Ventura County Community College District

DATE: May 15, 2025
TO: All Bidders
FROM: Spencer Herson, Purchasing Specialist
SUBJECT: Addendum 1 – Bid 709, Ventura College Stem Program Building Improvements

Drawings: Changes and clarifications noted as Addendum 01 and dated 05/15/25

DROP OFF AREA
LIGHTING NEW
WORK AND
PHOTOMETRIC PLAN

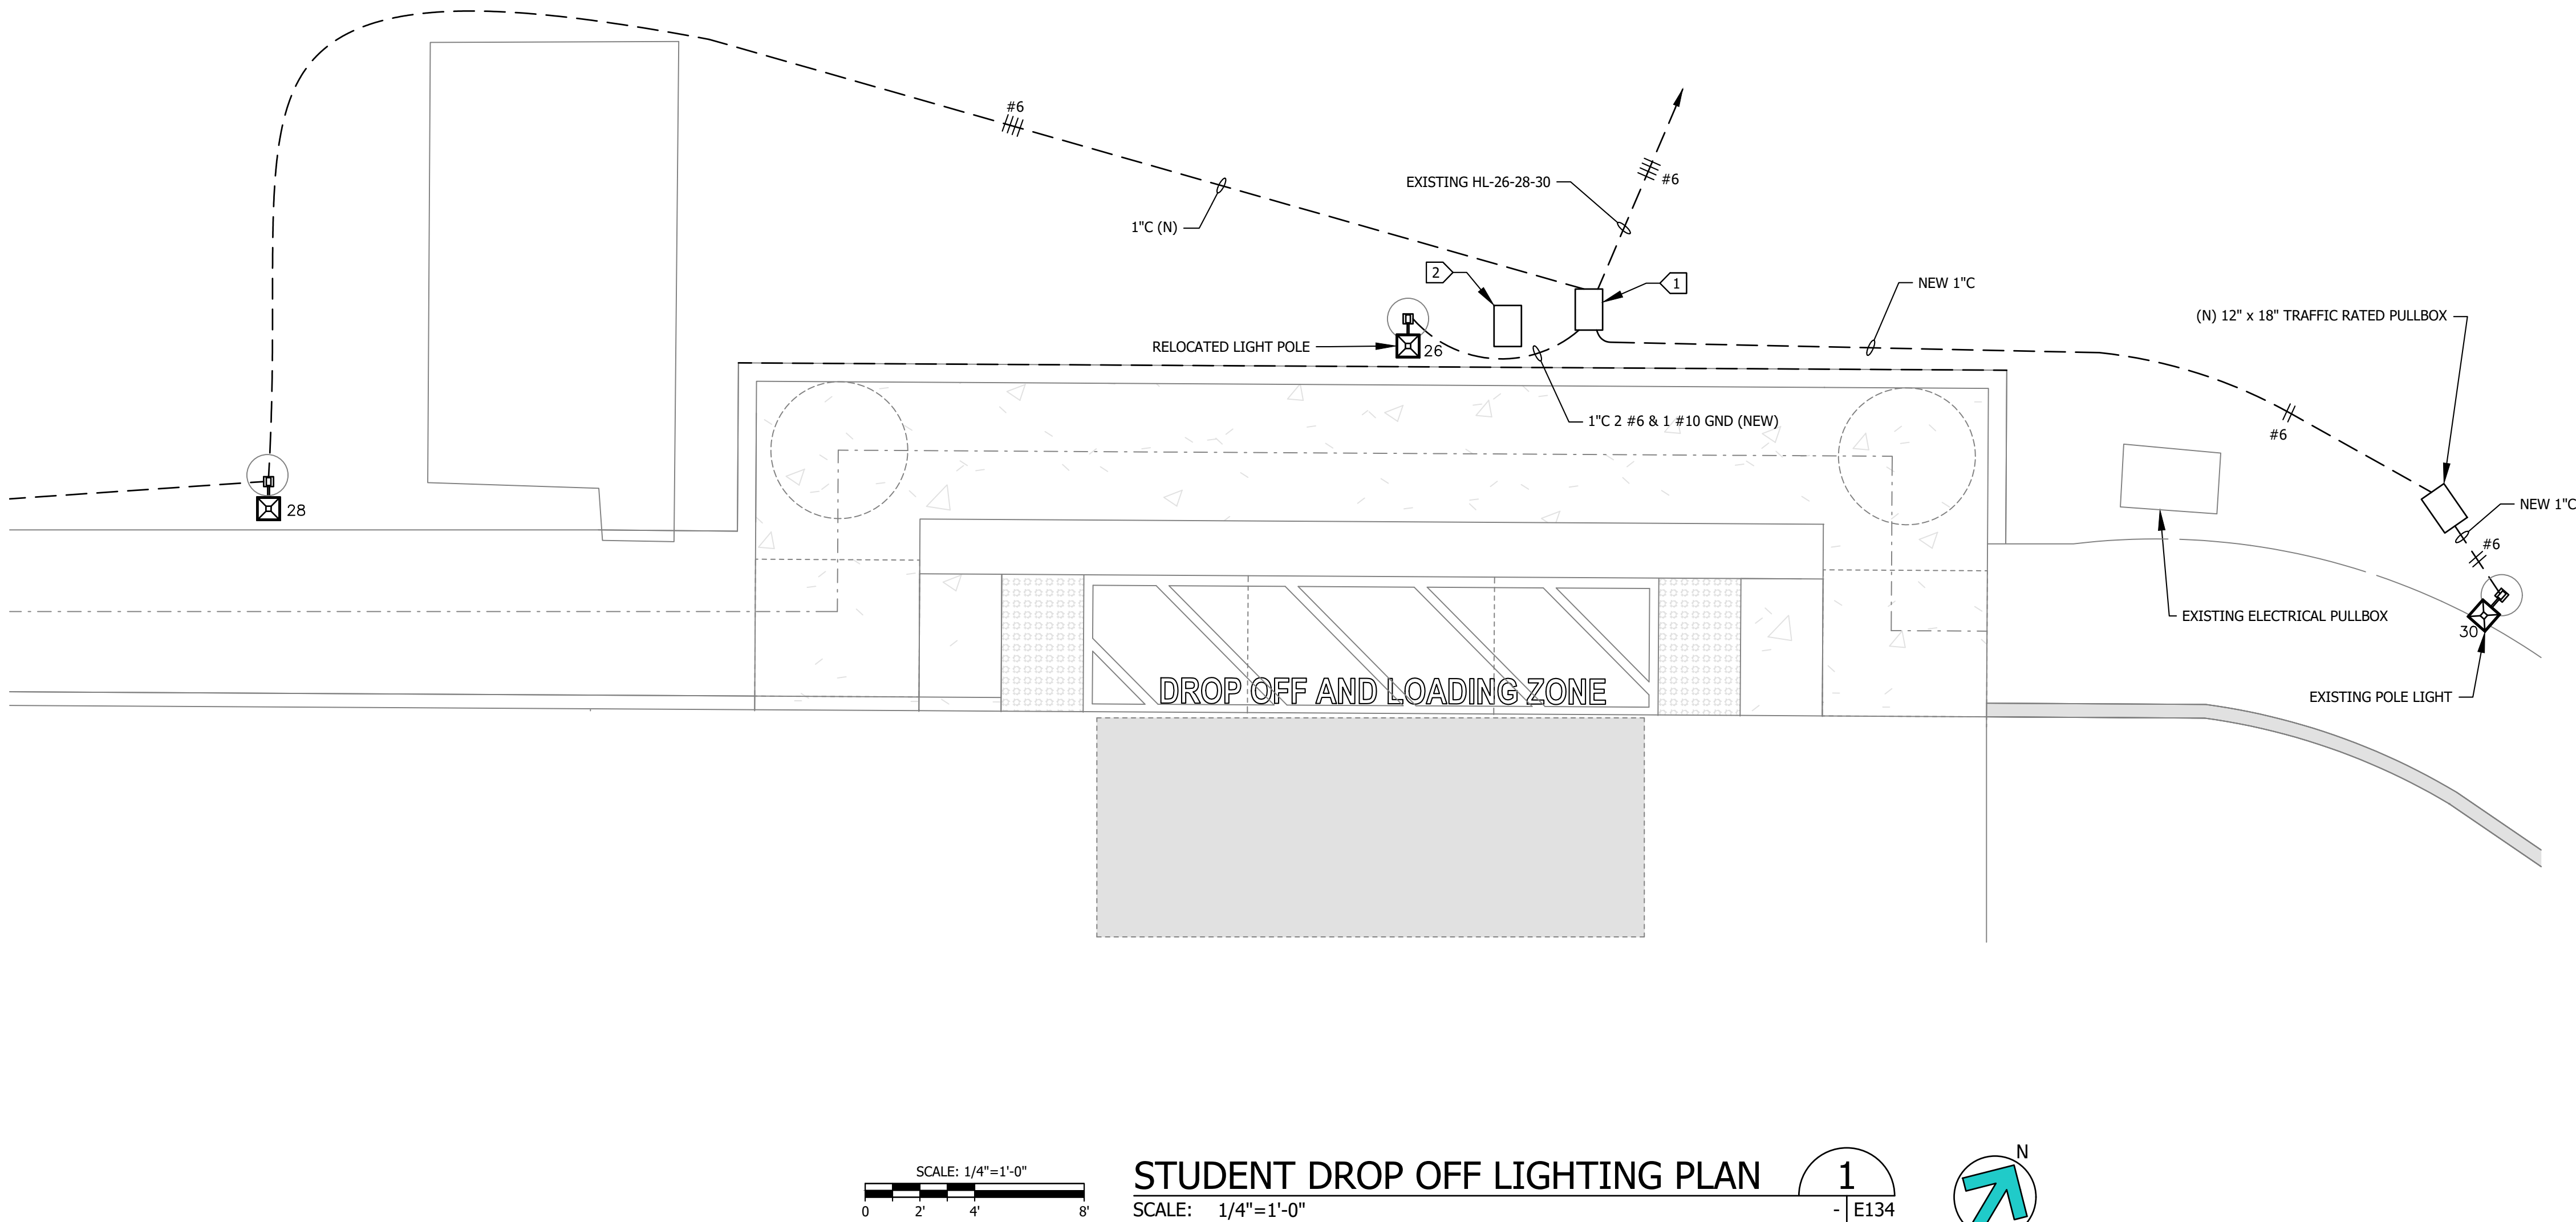
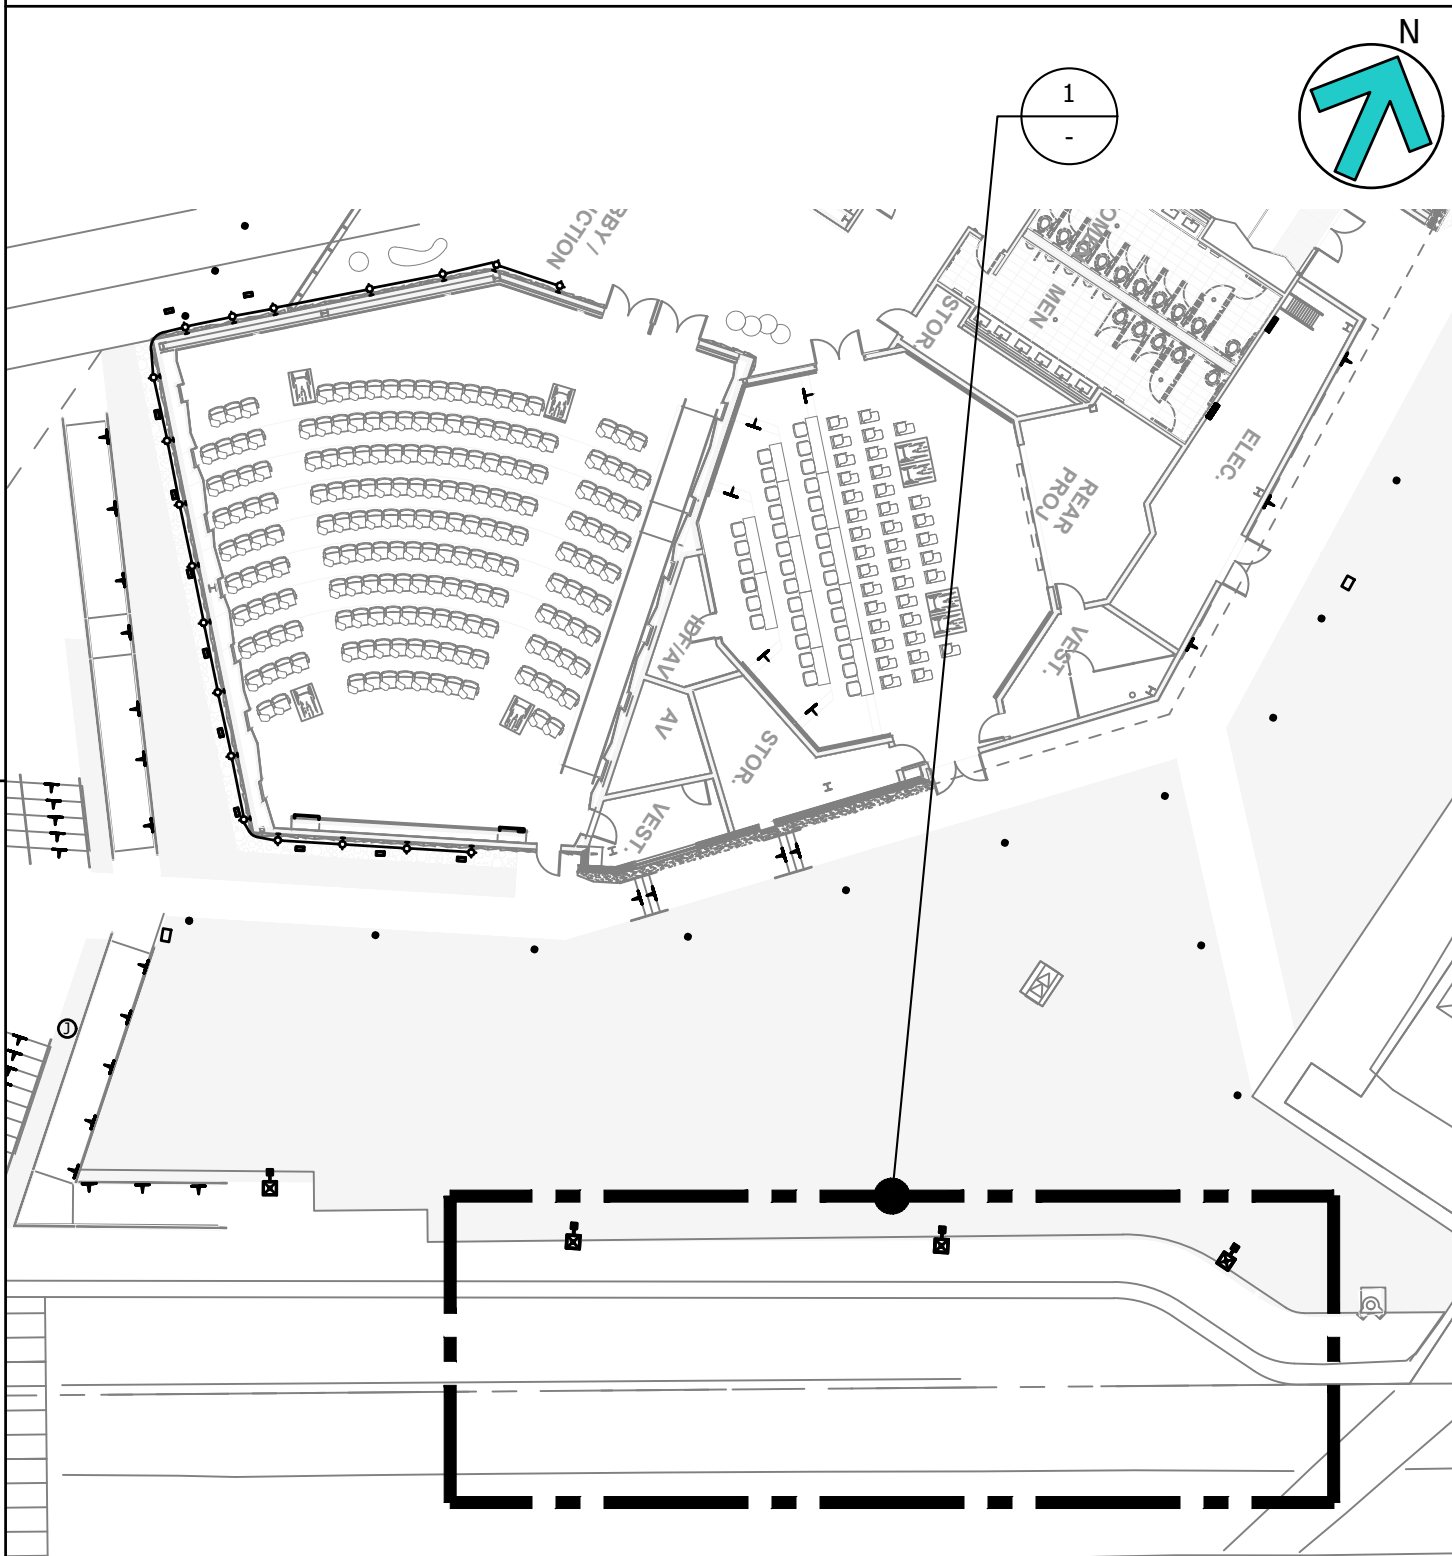
E134 – NEW DRAWING; DROP OFF AREA LIGHTING NEW WORK AND PHOTOMETRIC PLAN
